**AGENDA  
TOWN OF PITTSFORD  
PLANNING BOARD  
AUGUST 12, 2024**

**Passero Associates, Pittsford Oaks Apartments**  
Preliminary/Final Subdivision and Preliminary Site Plan

Re: **Pittsford Oaks Apartments Comments letter dated 7/3/2024**  
**Preliminary Site Plan & Preliminary/Final Subdivision**

This letter is regarding the comments letter received from the DRC for the above project dated July 3, 2024. The comments are listed in the order received and our responses are in bold italics.

**GARAGE FLOOR PLAN**

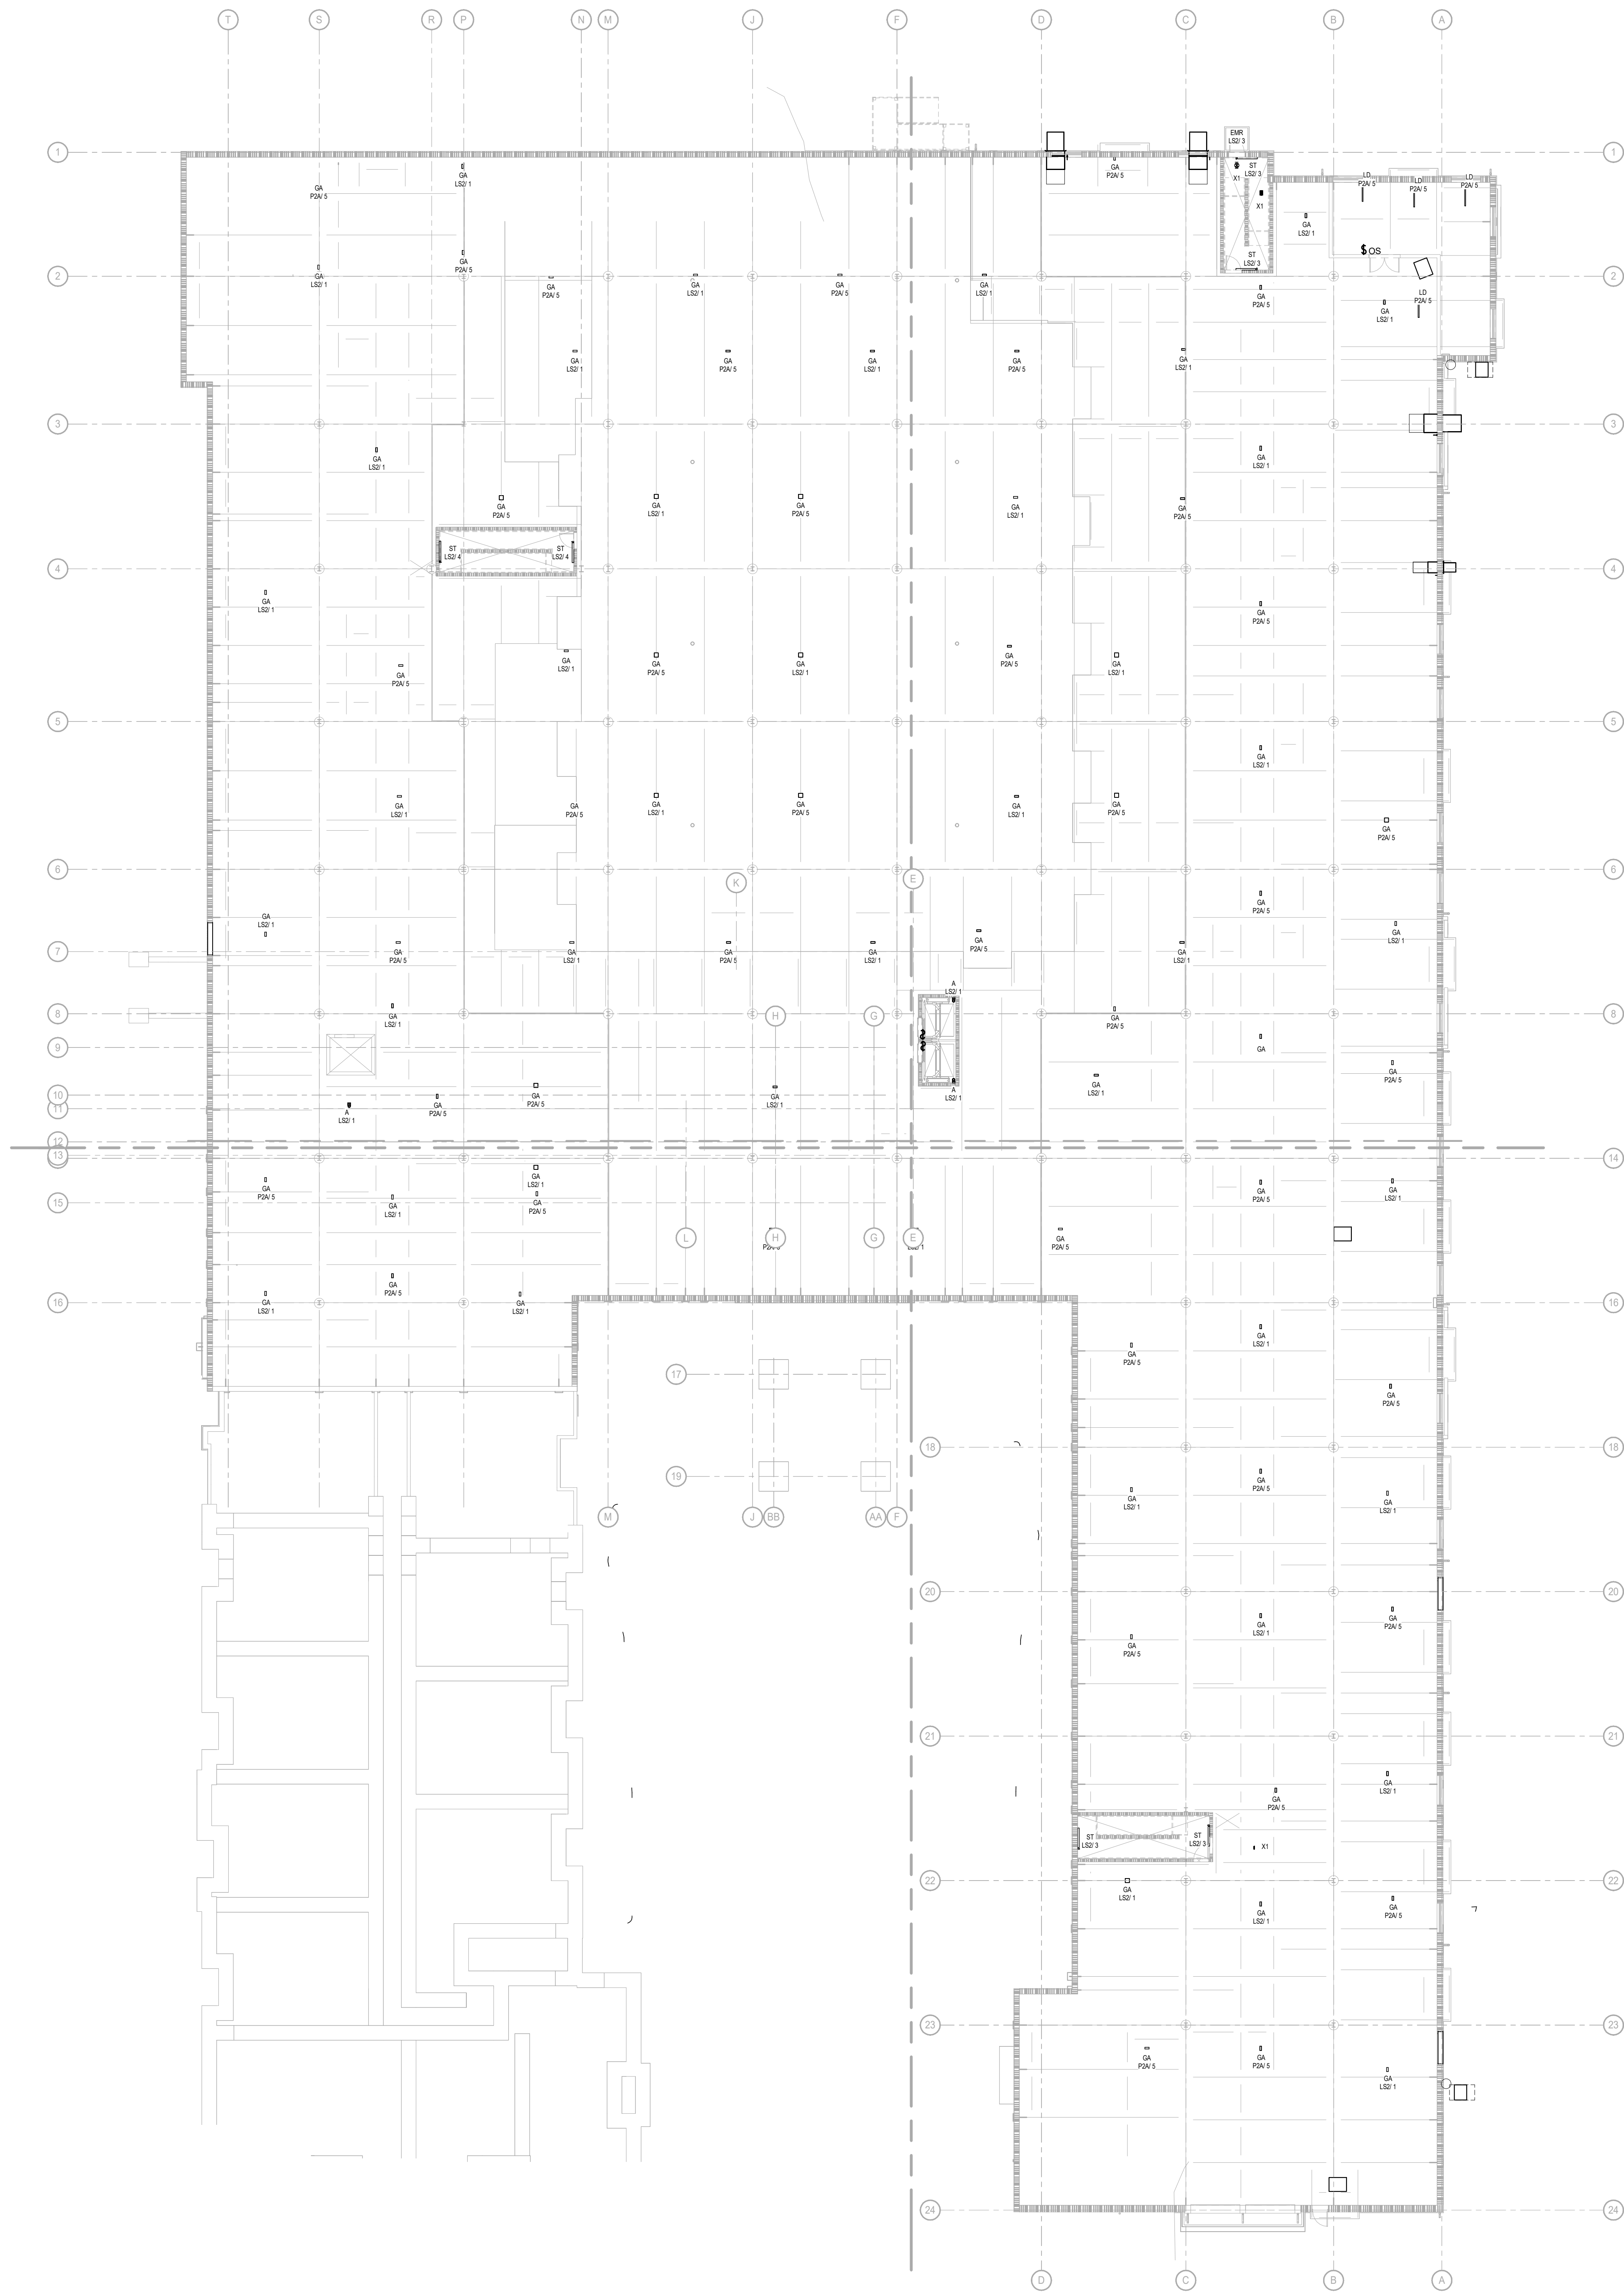
35. Please provide a plan sheet showing underground parking and facilities. This plan will be subject to further DRC review. (DPW)  
**Response: Underground Parking Plan provided as requested.**
